CONSTRUCTION SUMMARY

EARLGLEN INVESTMENTS INC.

LOT NUMBER	PHASE	HOUSE TYPE	CLOSING DATE	
103 BLOCK 017	1	THE KATHERINE(END)-ELEV A-3 BDRM-3 BATHS	08-Sep-26

Lot: 103 BLOCK 017 Project: EARLGLEN INVESTMENTS INC. Model: THE KATHERINE(END)-ELEV A-3 BDRM-3 BATHS

LOWER LEVEL
ELEV.A,

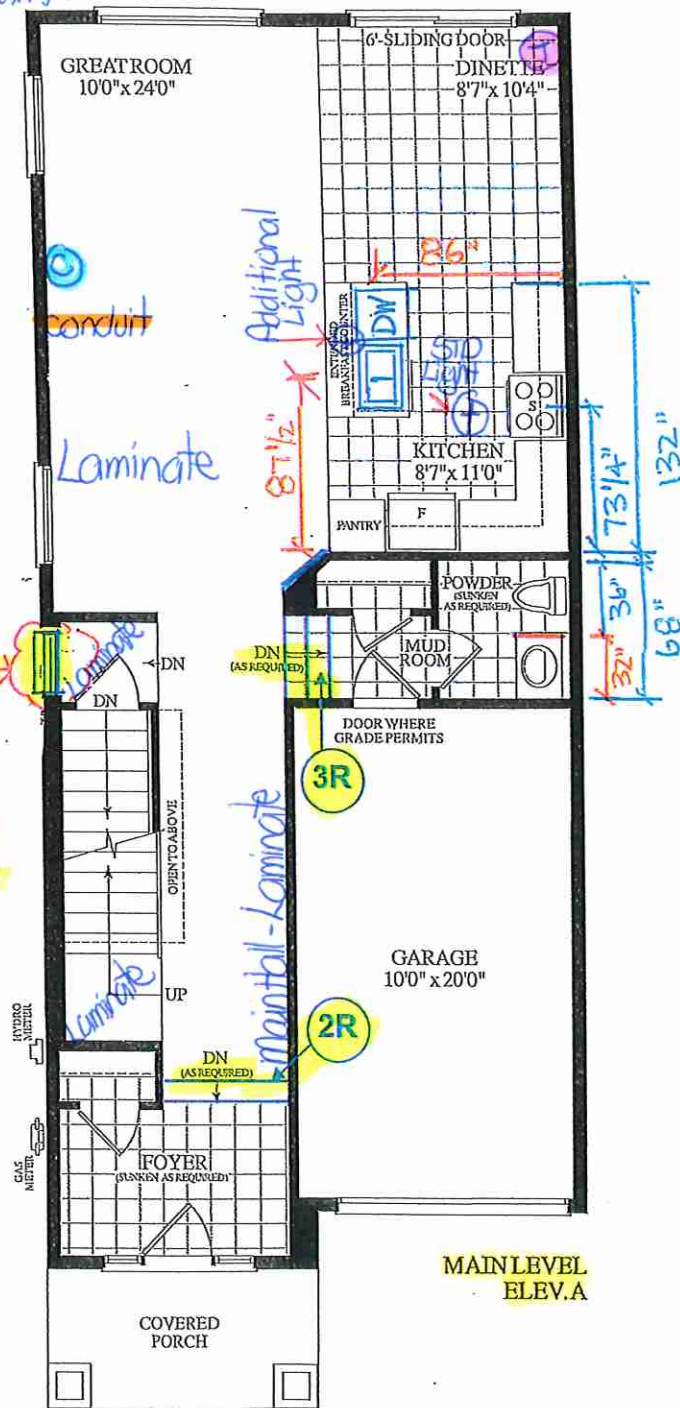
1 - SIDE EXTERIOR - Install ONE (1) WINDOW Approx. 24" x 48" (Operative) at side exterior elevation (See Sketch)
To Include; Larger Header to Accommodate Future Side Door - As per Fonzie C.
Note: Approved as per Fonzie C.

1 - BASEMENT - WINDOWS - Enlarge ONE (x1) Basement Window at Rear Elevation from Stnadard 30 IN (W) x 16 IN (H) To LARGER 30 IN (W) x 24 IN (H) (with Possible Window Well) (See Sketch)
Note: Purchaser Accepts & Acknowledges Two (2) Remaining Basement Windows will Remain Standard Size of 30 IN (W) x 16 IN (H) (with possible window wells)

1 - CLARIFICATION;
COLD CELLAR - Purchaser has DECLINED Upgrade to install window at cold cellar. Purchaser accepts and acknowledges NO Window will be installed at cold cellar as per standard plan (See Sketch)
Note:

Install
24" x 48" —
Window
C.R.N FOR
FUTURE
SIDE DOOR
(35" x 83")

EDGE DETAILS

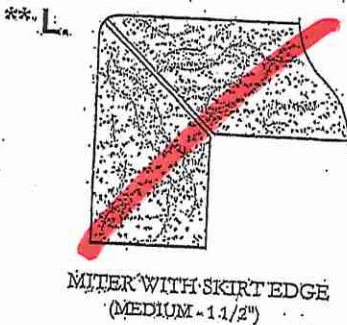
1 - KITCHEN - KITCHEN SINK - Install Builders Standard Undermount Sink – Kindred Undermount Sink – Model #RDU 1831/7 Note:
1 - KITCHEN - KITCHEN FAUCET - Install Builders Standard Faucet - MOEN Method Single Handle Pull-Out (Single Hole) Kitchen Faucet - Model # 7585 – Chrome Note:
1 - POWDER ROOM - COUNTERTOP - Install Builders Standard Stone Countertop – EVEREST MAPLE WHITE with STANDARD " A " EDGE PROFILE - To be installed throughout powder room vanity, where applicable (Includes Applicable Splash) (See Sketch) Note:
1 - PRIMARY ENSUITE - COUNTERTOP - Install Builders Standard Stone Countertop – EVEREST MAPLE WHITE with STANDARD " A " EDGE PROFILE - To be installed throughout primary ensuite vanity, where applicable (Includes Applicable Splash) (See Sketch) Note:
1 - MAIN BATH - COUNTERTOP - Install Builders Standard Stone Countertop – EVEREST MAPLE WHITE with STANDARD " A " EDGE PROFILE - To be installed throughout main bath vanity, where applicable (Includes Applicable Splash) (See Sketch) Note:

1 - ENSUITE #2 - COUNTERTOP - Install Builders Standard Stone Countertop – EVEREST MAPLE WHITE with STANDARD " A " EDGE PROFILE - To be installed throughout ensuite #2 vanity, where applicable (Includes Applicable Splash) (See Sketch) Note:
1 - DISCLAIMER - STONE COUNTERTOP; ALL BATHROOMS - Due to the many variables that can affect the pattern, colour and/or design and “pitting” of stone products, stone installed will not be identical to the samples displayed. Note: Every effort is made to provide stone countertops as close as possible but the vendor is not responsible for results which differ from the sample displayed. All countertop surfaces may have seams, and product pattern and shade can change in areas containing seams.
1 - CLARIFICATION; PLUMBING FIXTURES & PLUMBIG FAUCETS; ALL BATHROOMS - Install Builders Standard Plumbing Fixtures and Install Builders Standard Plumbing Faucets throughout all bathrooms, where applicable. Note: To Include; Powder Room, Primary Ensuite, Main Bath & Ensuite #2 (See Sketch)
